**MOUNTAIN BROOK VILLAGES  
 COMPREHENSIVE  
 DEVELOPMENT PLAN**  
 ROANOKE, VIRGINIA

**C-10**  
 Sheet 13 of 27

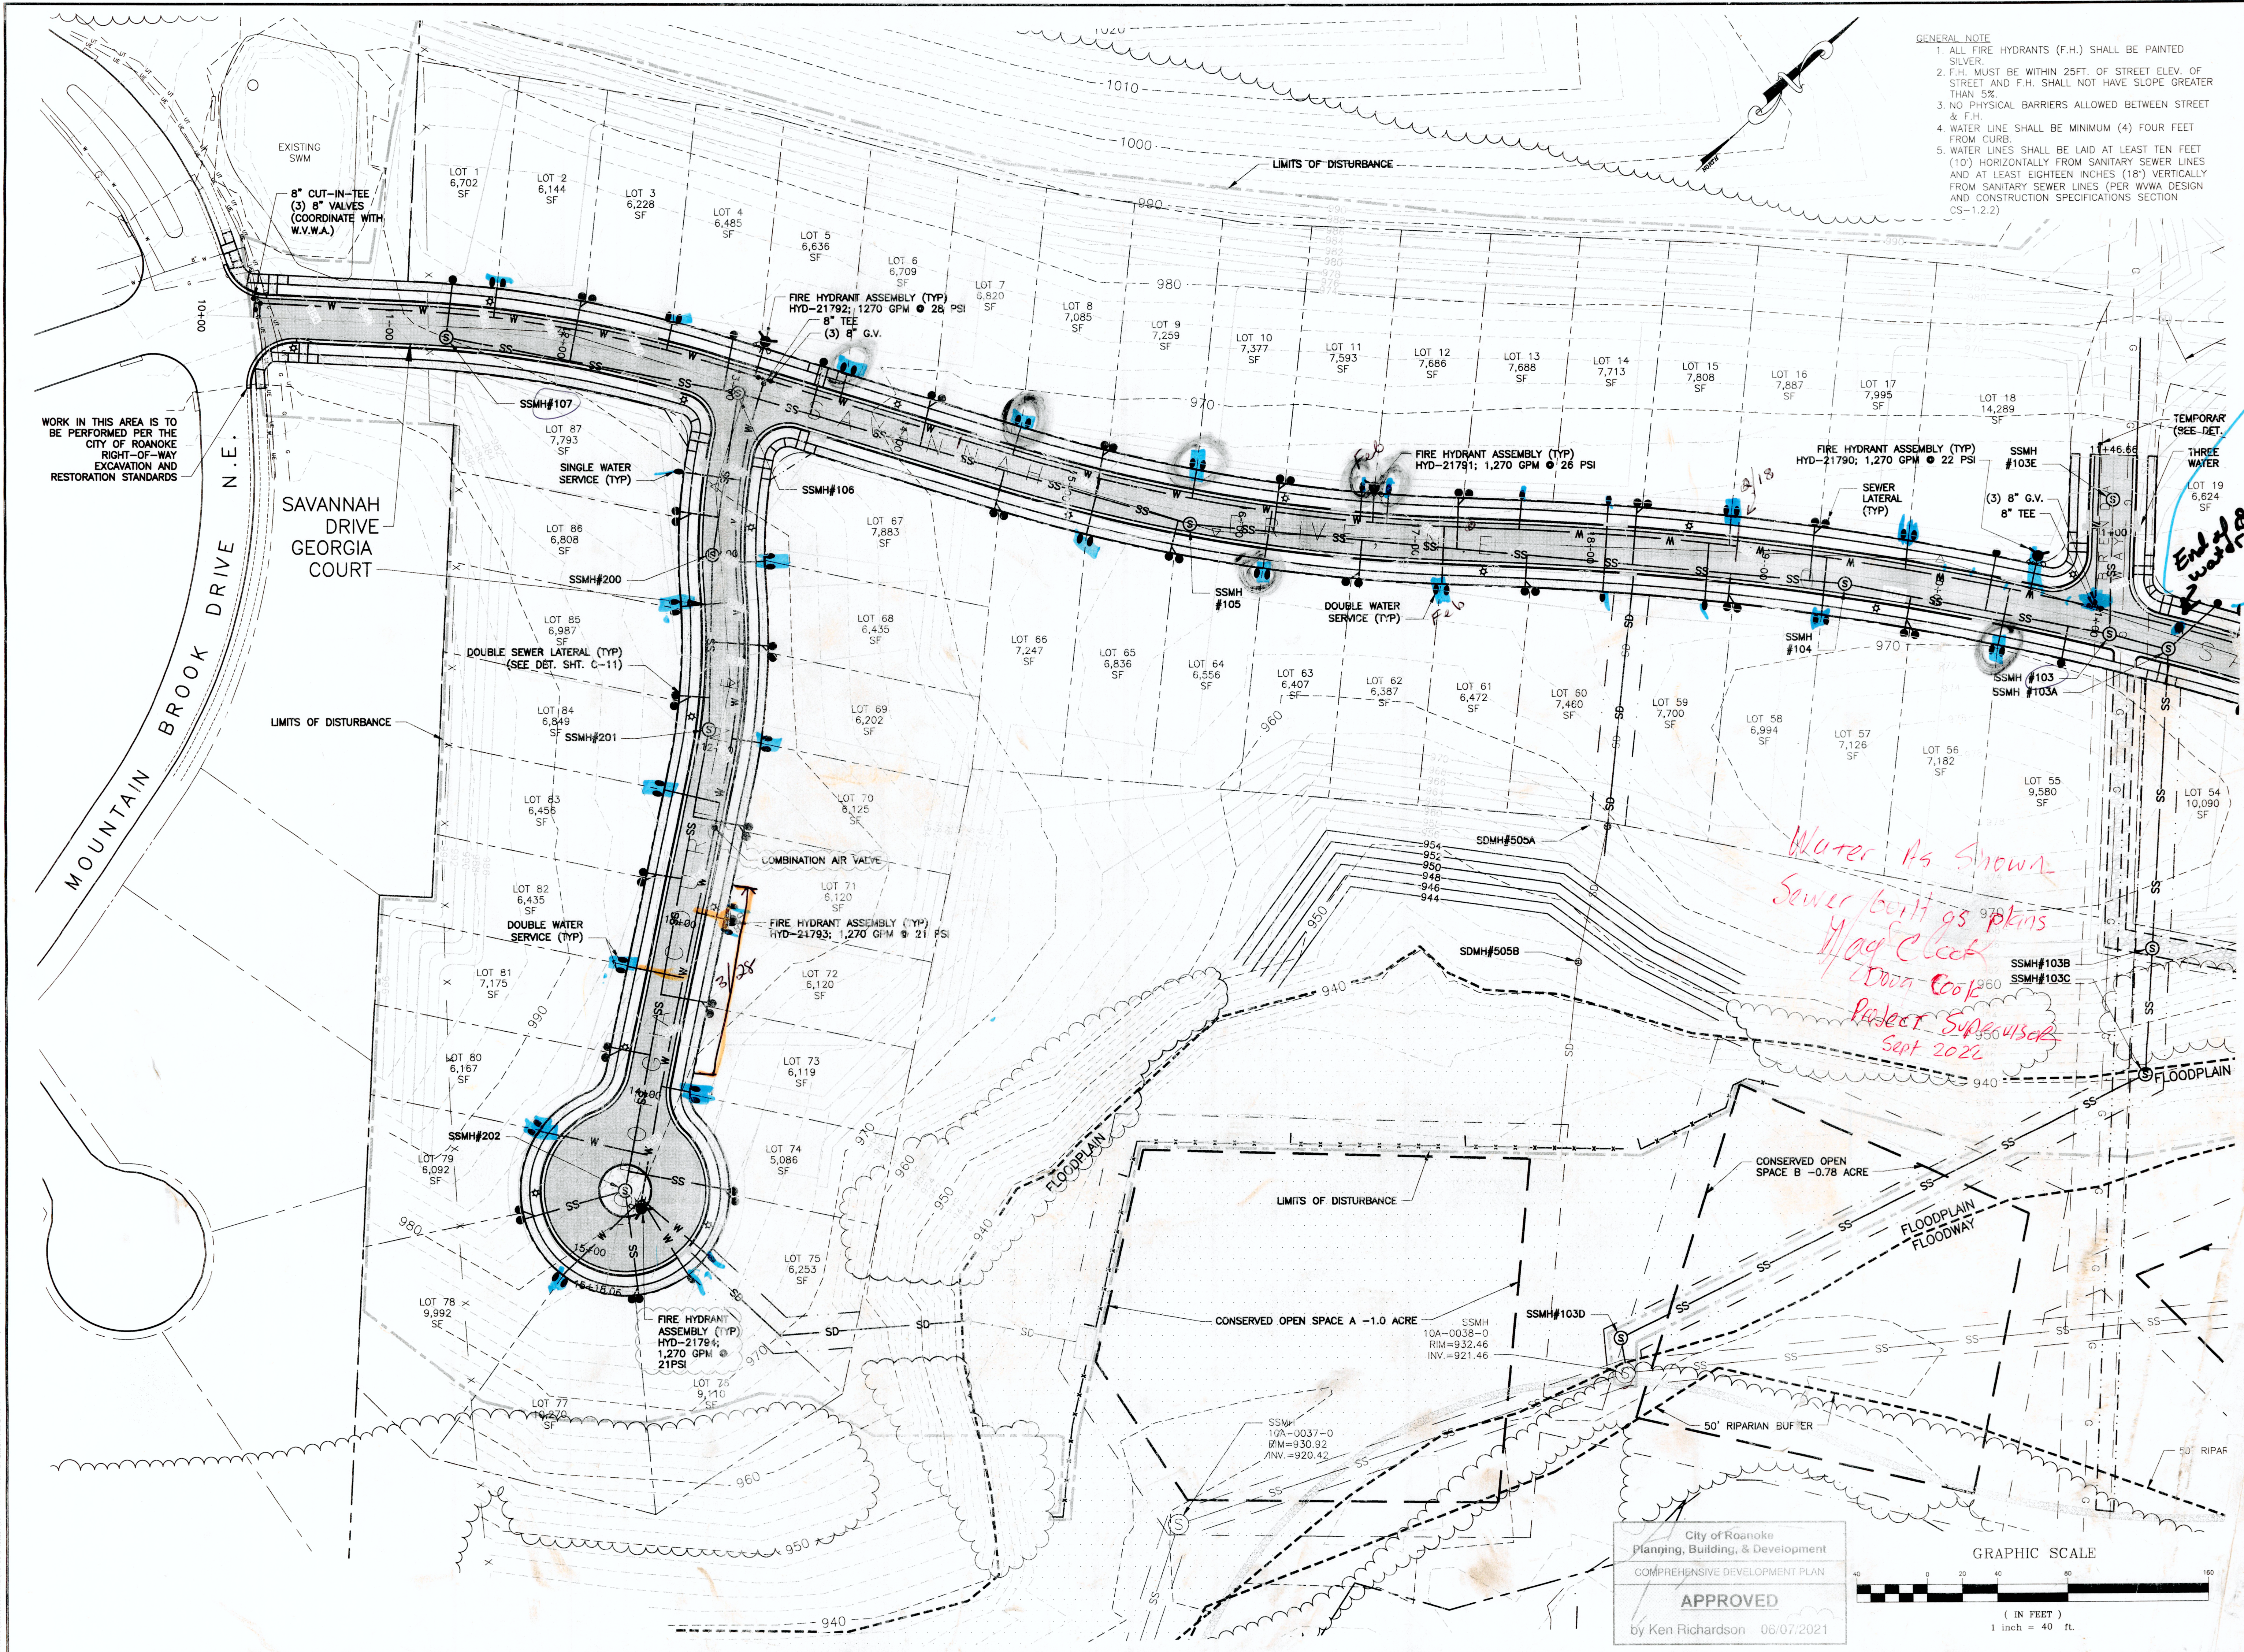
*End of 1st water line  
 6' Dan Hill  
 12' away from  
 Sewer M.H. #  
 103A*

*Water As Shown  
 Sewer built as plans  
 May Clock  
 Down Clock  
 Project Supervisor  
 Sept 2022*
